CITY OF VANCOUVER

POLICY REPORT
DEVELOPMENT AND BUILDING

SUBJECT: CD-1 Rezoning: 1752-1760 West 3rd Avenue

A2.2

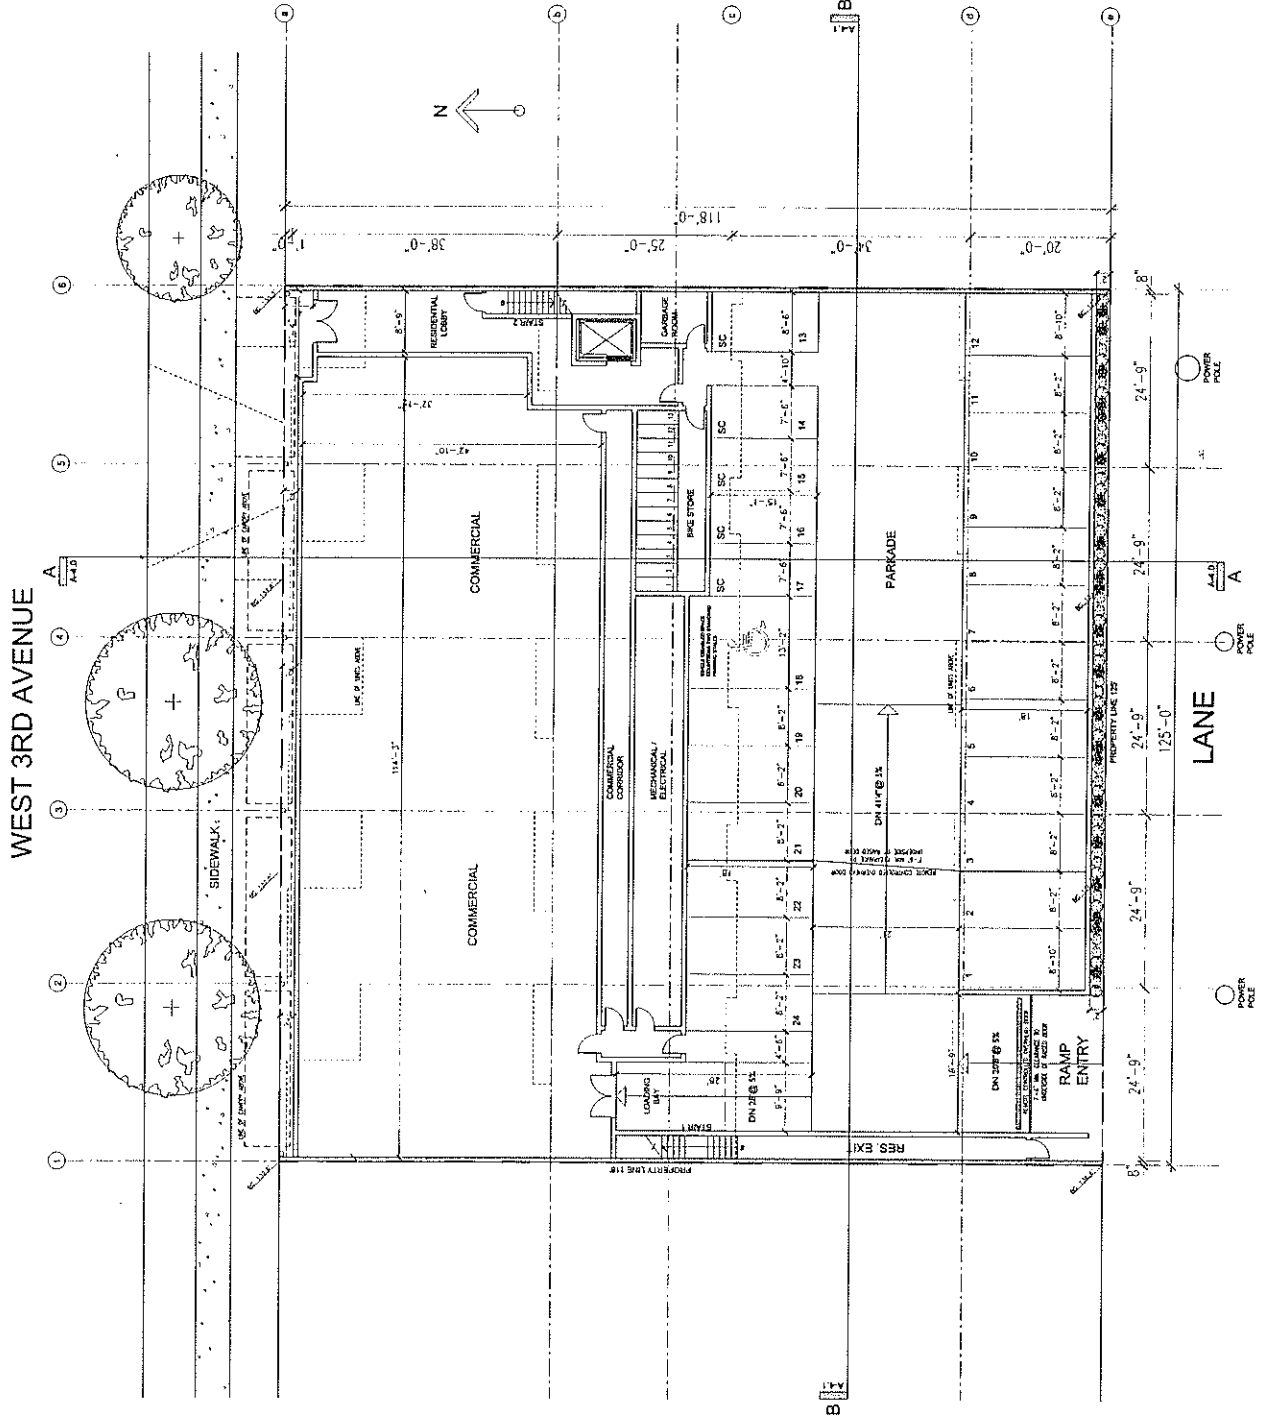
- (iv) design development to take into consideration the principles of CPTED having particular regard to reduce opportunities for theft in the residential parking by providing a solid wall to separate residential and commercial users;

- (viii) The loading bay should be redesigned to be at the lane with the garbage storage nearby.
- (ix) There should be fully separated garbage storage for each use and additional space for recycling needs. Clarification of the pick up operation will be required.
- (x) The required manoeuvring aisle of 6.6m (21'-8") adjacent parking stalls is required.
- (xi) Additional width is required for some parking stalls (2, 3, 21 and 22).

A3.2

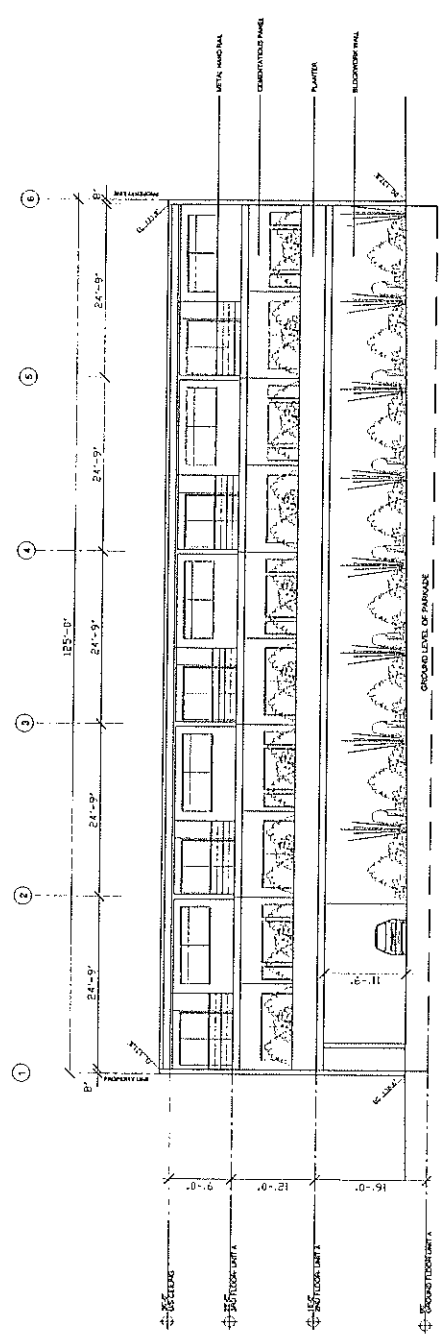
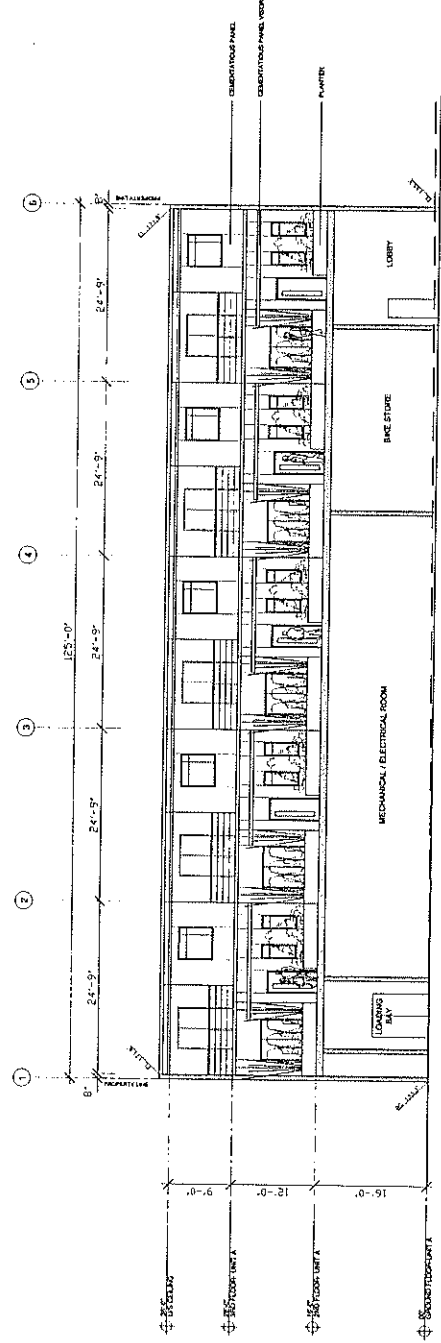
- (i) design development to increase the sunlight access to the courtyard by providing 30 ft. clear between the front and back of the second floor units and consideration to lower the party walls at each end of the courtyard;
- (ii) design development to provide a more distinctive residential entrance at the street and to provide natural light from the courtyard to extend into the lobby through a skylight;
- (iii) clarify material treatments for the frame element shown on the 3rd Avenue façade;

With respect to the form of development, concerns were expressed about to the courtyard. Given the limited private open space elsewhere in the building and the likely limited usability of the rear decks, the Panel thought more effort should be put into the design of the courtyard to maximize the sense of community with some common amenity space and to provide more light access. Deleting some or all of the end walls of the courtyard was strongly recommended. It was not thought to be a Building Code issue. The courtyard was considered to be somewhat relentless at its south edge. One suggestion for improving the quality of the courtyard was to consider flipping the bedroom balcony on the upper units. As well, there was a comment that the concrete walls in the north courtyard will promote heat gain, affecting the livability of the top units.
